## INTERNAL MEMORANDUM

**Subject:** Skagway West Creek Subdivision Planning Review

### PLANNING REVIEW

**Figure 1**

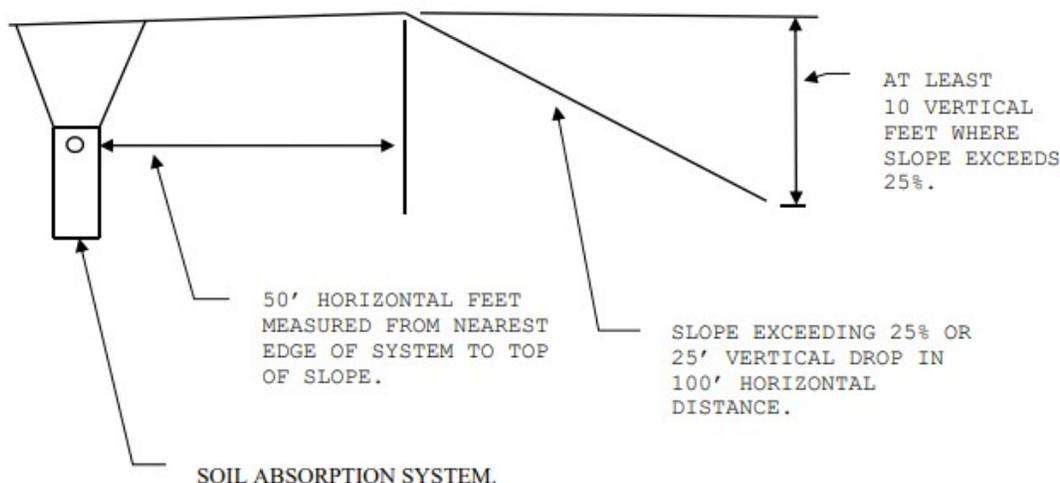
18AAC 72.035 outlines septic specifications based on minimum gallons, capacity, number of bedrooms in the residence, access openings, and frost protection by location. 18 AAC 72.035(d)(8) and (9) state the ground surface slope must be less than or equal to 25% for trenches and less or equal to 10% for beds while there is also 50ft of separation between any part of the soil absorption system from any slope greater than 25% with a surface height greater than 10ft. See the diagram figure below with additional requirements from ADEC 18 AAC 72 Water Disposal 2017.
